SOUTHEASTERN DISTRICT HEALTH DEPARTMENT  
INDIVIDUAL SEWAGE DISPOSAL INSTALLATION PERMIT

Date 25 March '75

Permit No. \_\_\_\_\_  
Installation for Kenneth Lyon at NE 1/4 NW 1/4 Section 33 T6S R34E  
(Name) (Legal description of property)

Applicant's sketch of house, proposed sewage layout and all adjacent wells (dimension between all components) --

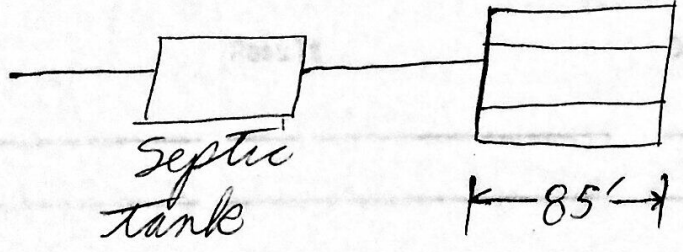
4 drain lines 85' long  
changed to a  
absorption bed  
of 20' by 50' - 2 May 1975
